## Staff Report to the Plan Commission

### Bridlewood Residential Planned Development

**Project:** 2025-0171 - Bridlewood Residential Planned Development

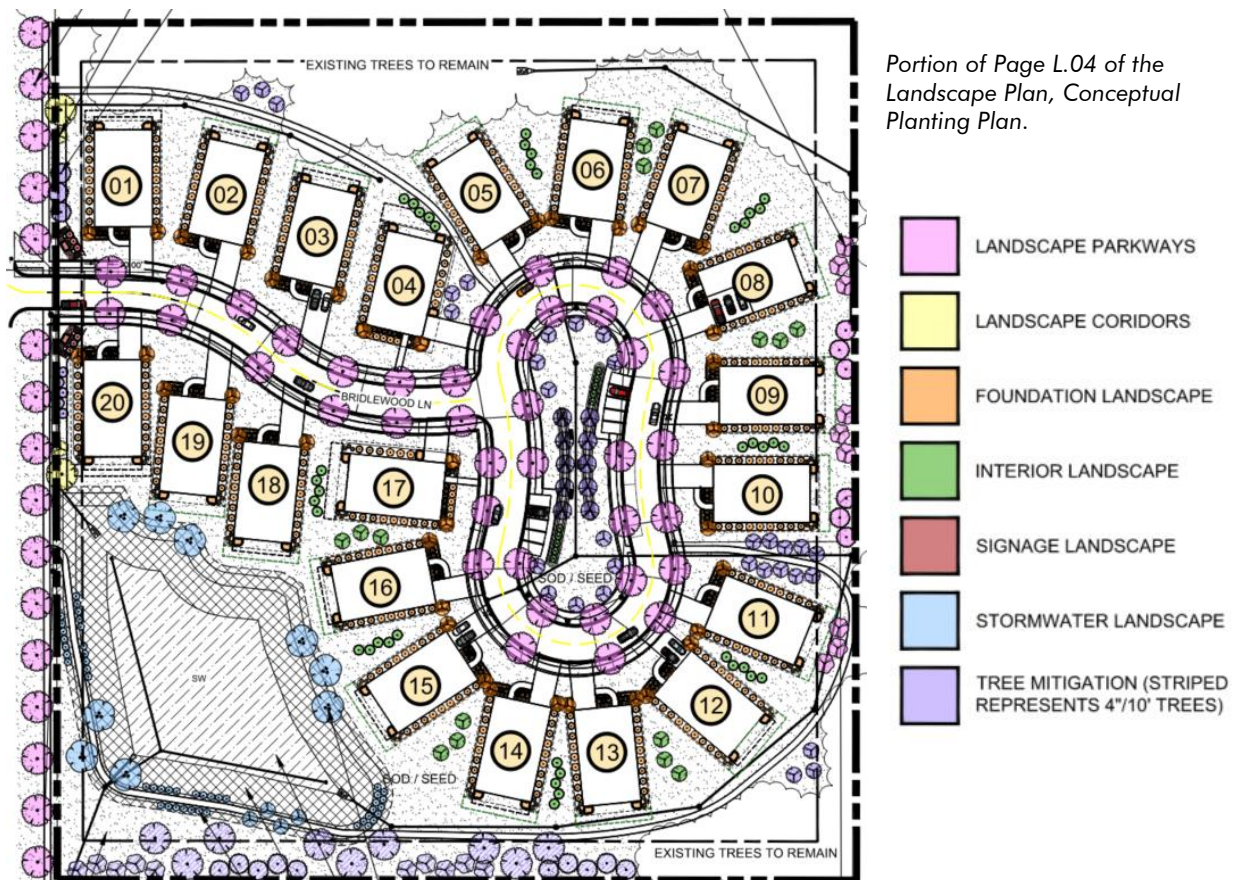
A existing wetland area is located within the northern portion of the proposed Planned Development. Per LDC Section 6-410.D.1, any activity occurring within 50 feet of a nontidal wetland requires a Special Use Permit. Page C3-0 of the civil engineering plans show the limits of

the existing wetland area, and Staff recommends approval of the requested Special Use Permit, as there is no disturbance to the actual limits of the wetland, but there are changes proposed within 50 feet of the wetland boundary.

A No Permit Required letter has been issued by the Army Corps of Engineers, outlining that there should be no impacts to the proposed wetland boundaries. The NPR letter states that no discharging of dredged or fill material is proposed into any aquatic resources subject to regulation under the Clean Water Act. Appropriate soil erosion and sediment control measures are required throughout construction of the proposed development. Potential impacts to the wetland buffer area, however, will require a WMO permit prior to final engineering approval.
